**Chevy Chase Village
Board of Managers**

Continuance of A-6895 (Appeal of the Manager's Decision):

**Mr. Christopher Ian & Ms. Victoria Twinn of 5503 Center Street and Mr. David & Ms. Julia Lee of 5505 Center Street
Regarding Work at 5502 Grove Street**

STAFF INFORMATION REPORT

Figure 4: Contour lines and watershed limits before the grading

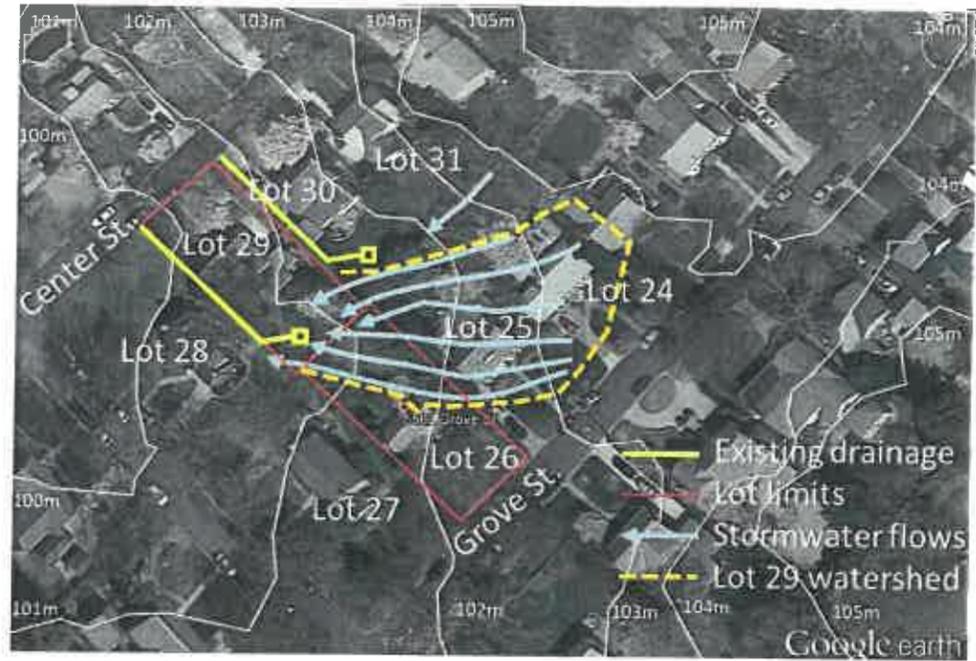
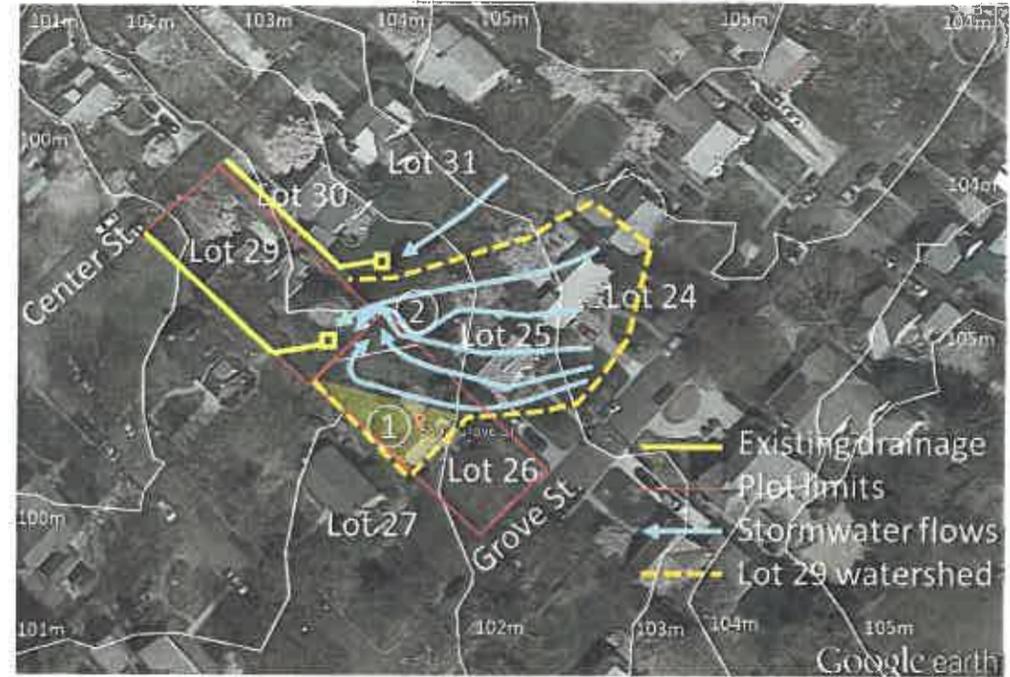
- a. **Before:** Water from the roof and the western part of the Lot used to flow towards Lots 27 and 28, directly or through the corner of Lot 29 (figure 4).
- b. **After:** By installing the storm water chamber connected to the roof gutters the water from the roofs that used to flow towards Lot 27 & 28 now is spread in the middle of the backyard and flows under the fence towards Lots 30 and 29, increasing the amount of water and overloading the drainage system with additional water (figure 6).

Figure 5: water flows in Lot 26 before grading

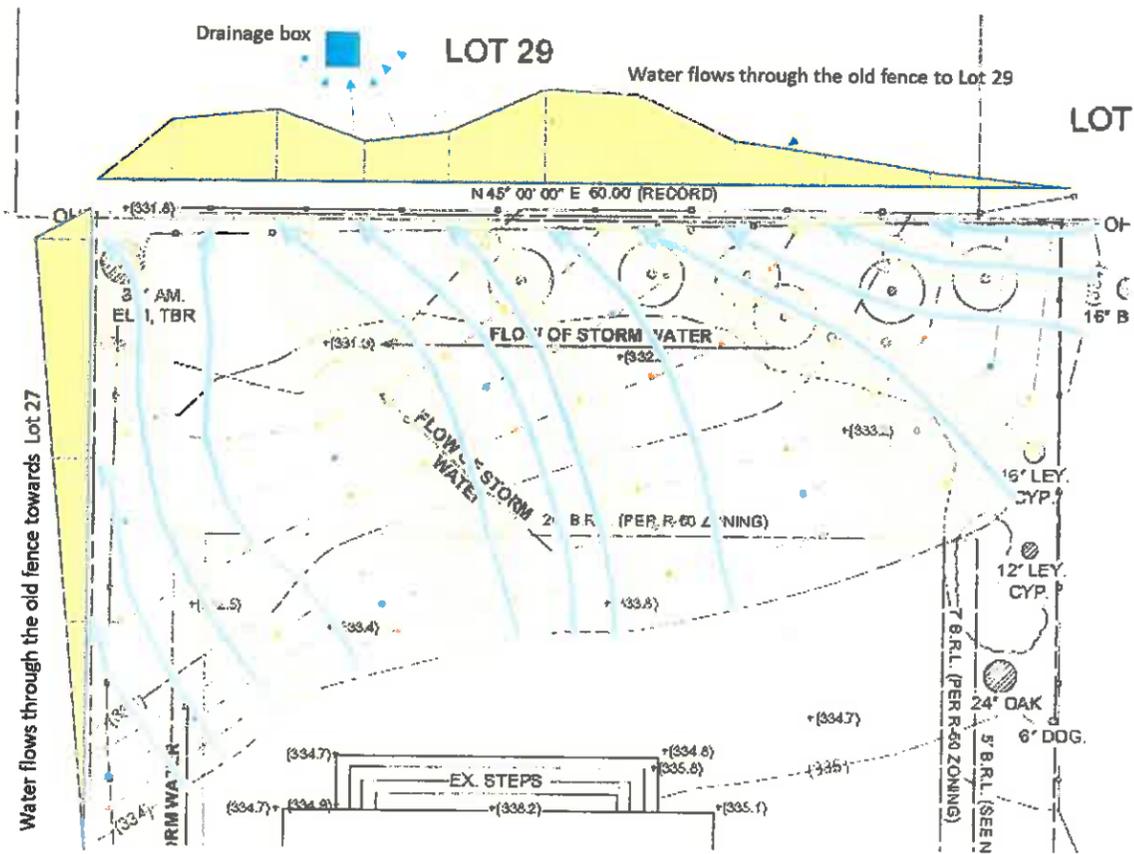
- a. **Before:** Lot 26 had a slope towards Lots 29 & 27 and water used to flow to Lot 29 mainly through two points in the fence (see figure 5), one in the middle towards the drainage box and the other one close to Lot 28. Water close to Lot 27 used to continue flowing towards Lot 28 and 27 not using the drainage system at Lot 29. The existing drainage system in Lots 29 and 30 were designed after a careful and systemic analysis of the water flows entering those yards. Figure 5 shows how the water used to flow from Lot 26 to Lots 27 & 29.

Figure 8: Proposal from the owners of Lot 26

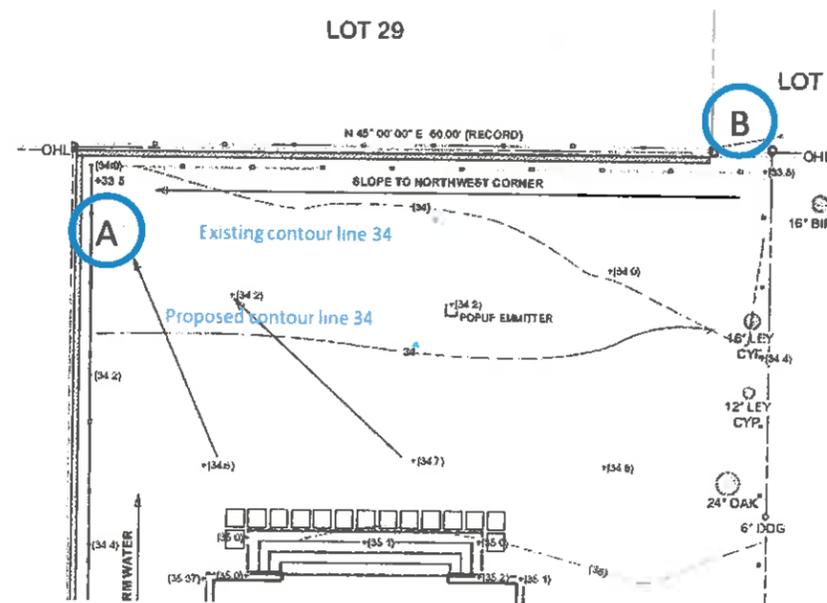
Unfortunately, the solution described in the drawing (figure 8) provided by the advisor to the Roses does not have enough information to judge it. It might be because of some missing pages or because there is a lack of definition. Apparently it seems that some soil will be removed close to the wall to allow water flow towards Lot 29 or Lot 27 through the wall. In any case, there is missing information about land height:

- Detail of the land height in the area close to Lot 29: What will be the slope towards Lot 27 (northwest corner ie. area A in figure 8)? Will it be lower than the point where there is no wall (Lot 25 ie. Area B in figure 8)?
- Detail of the land height in the area close to Lot 27: Will the water from the popup emitter flow again towards Lot 27?

- **The watershed seems to remain as it is right now, since the popup emitter will pour water towards Lot 29. That means that additional water will be flowing to Lot 29 instead of flowing to Lot 27 as before and frequent floods will occur since the drainage system installed in Lot 29 will be overloaded.**

- **The only way that water may find to flow towards Lot 29 is through the wall, and consequently only filtered water through the ground will make it. The flow of water through filtered soil is significantly less than the flow at the surface, so only a little amount of the water will be filtered and most of it will flow on the surface. Since the proposal is undefined, the only efficient solution is to remove the soil at a lower level than the shown in photo#1 of figure 1 (where the wall ends) and make proper drainage holes in the wall. Otherwise, the water will accumulate and will flow again under the fence where there is no wall and it is currently the lowest point in Lot 26 (area B).**

Figure 11: Alternative 1 floor drawing

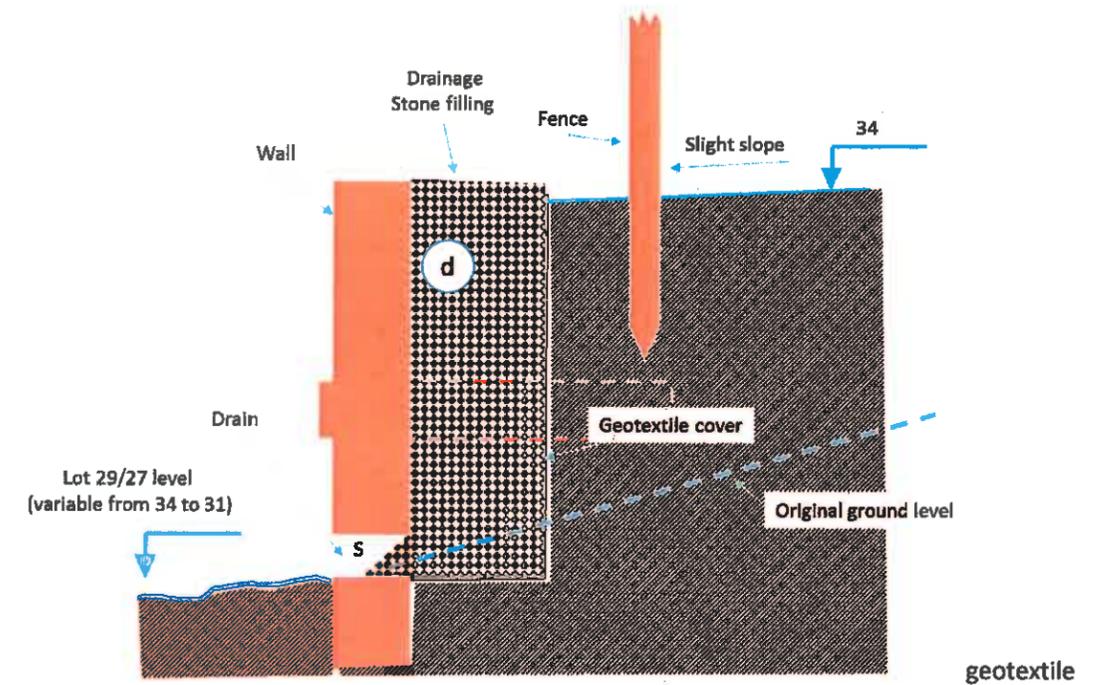
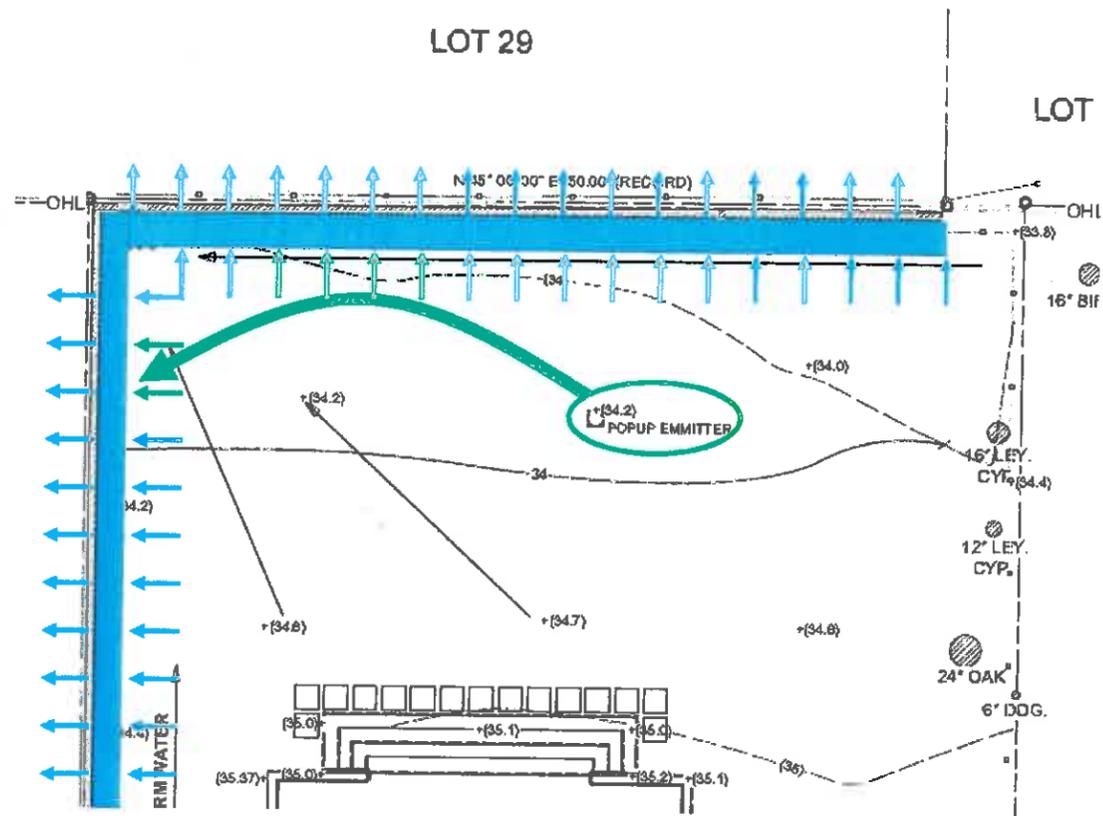
Alternative 1: Wall Drains + Move Popup Emitter

This alternative consist of a stone-filled drain with a geotextile sheet along the wall at the original land height (figure 9) that will allow water to follow the same path as it was before the grading (figure 11). In order to make sure that the water does not accumulate behind the wall, it must have enough drains to let water flow out (figure 10). This alternative is valid for both walls in the boundaries with Lot 29 and with Lot 27.

The popup emitter that brings the water from the roof should be moved to a place where the water only could pour to Lot 27, according to the previous situation (figure 11) to avoid increase the amount of water flowing to Lot 29.

- Stone size (d)
- Drainage width (w) – is a function of the stone size and the evacuation flow
- Drain section (s) – depends on the evacuation flow
- Drain spacing (L) – Is a function of the drain section. In order to replicate the previous situation (pre-wall), in the center of the wall sections would have to be larger or L would need to be shorter (figure 10).

Figure 13: Alternative 2 floor drawing

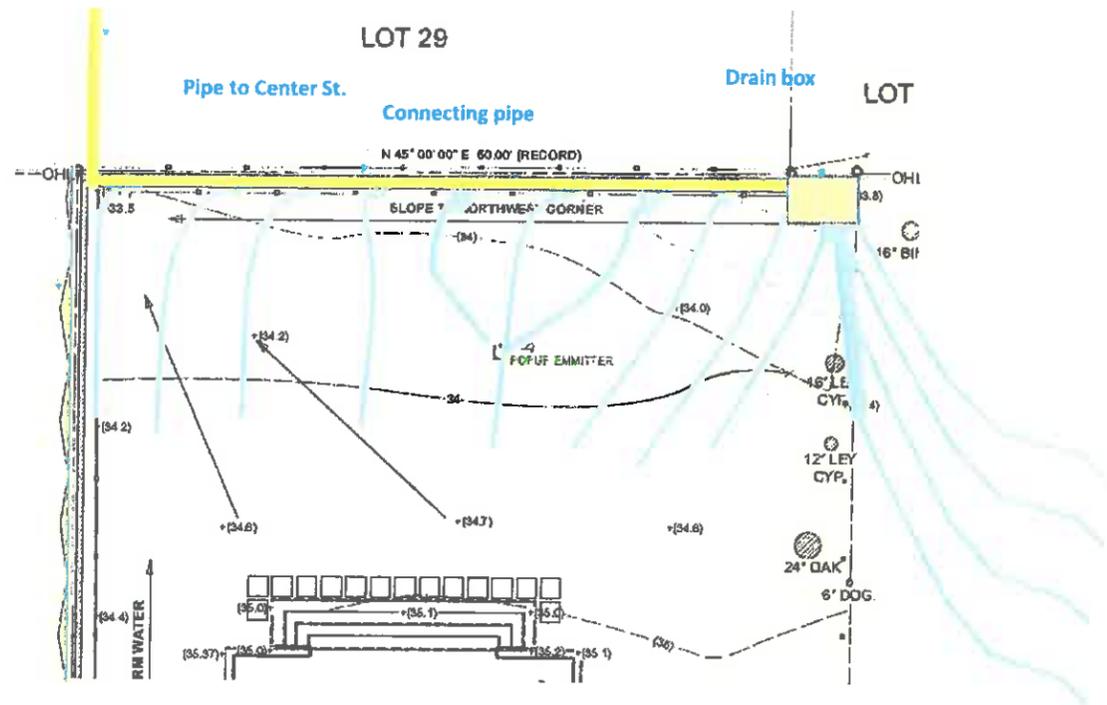
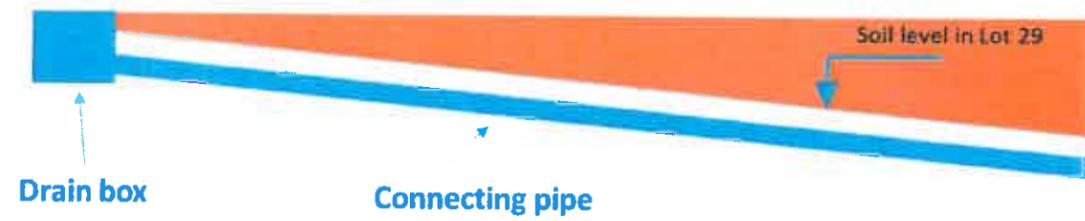
Alternative 2: Drain box + Evacuation Pipe

The inconvenient for the owners of Lot 29 is that a part of the pipe would have to be dug in their property. If the owner of Lot 26 does not clean properly the box or his section of the pipe, the problem would come back again. It is advised to leave a 2 feet width corridor between the wall and the fence for maintenance purposes.

The connection along the limit with Lot 30 wouldn't be possible since the height difference between Center St. and the drain box wouldn't be enough or would require a too large section for the pipe. For the proposed alternative the **minimum pipe section should be at least 5 inches** and the box size should cover the gap between the property limits and the end of the wall. The box depth, which could also include a chamber, would have to be deep enough to feed the pipe and the pipe should have an adequate slope.

Final Proposed Plan

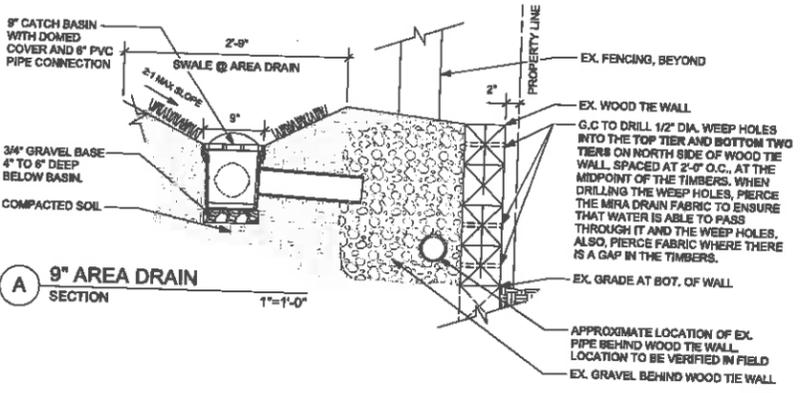
NOTE: 1/2" DIA. WEEP HOLES TO BE DRILLED INTO THE TOP TIER AND BOTTOM TWO TIERS ON NORTH SIDE OF WOOD TIE WALL, SPACED AT 2'-0" O.C., AT THE MIDPOINT OF THE TIERS. WHEN DRILLING THE WEEP HOLES, PIERCE THE MIRA DRAIN FABRIC TO ENSURE THAT WATER IS ABLE TO PASS THROUGH IT AND THE WEEP HOLES. ALSO, PIERCE FABRIC WHERE THERE IS A GAP IN THE TIERS.

NOTE: G.C. TO CAP EX. 4" PERFORATED PIPE BEHIND WOOD TIE WALL AND REMOVE 5'-0" LENGTH OF GRAVEL BEHIND THE NORTH EAST END OF THE WOOD TIE WALL. REPLACE GRAVEL WITH SUBSOIL.

Shift catch basin ten feet to the right (east) of the west property line at the Roses'
The addendum reflects this change, which has been agreed to by the Roses.

OIPA's letter included several other suggested modifications which we would welcome: (i) a proposal to increase the diameter of the pipe from the catch basin to the gravel drain tile to 6"; (ii) the use of a domed cover to reduce the probability of the catch basin clogging; (iii) possibly increasing the size of the catch basin to 9"; and (iv) additional weep holes being added in the retaining wall to allow more evenly distributed passage of the water through the wall. In addition, if the current design of the drain tile/Miradrain Board is indeed to direct water from behind the retaining wall back towards the right of the Rose's property, as described in the Village Engineer's letter of December 1, we would also welcome the capping of the perforated pipe and removal of gravel from final 5' of the retaining wall as proposed in OIPA's letter.

The addendum reflects this change, which has been agreed to by the Roses.

Increase size of prefabricated catch basin to 9" x 9" and provide a protective cover or screen

The addendum reflects this change, which has been agreed to by the Roses.

Provide additional weep holes along the top and bottom rows of the timber retaining wall

The addendum reflects this change, however, the Roses have expressed concerns that the number of proposed holes could compromise the structural stability of the wall.

Provide a cap at the east terminus of the drain pipe running parallel to the retaining wall and remove the gravel bed for the pipe for the last (easternmost) five feet of pipe

The addendum reflects this change, which has been agreed to by the Roses.
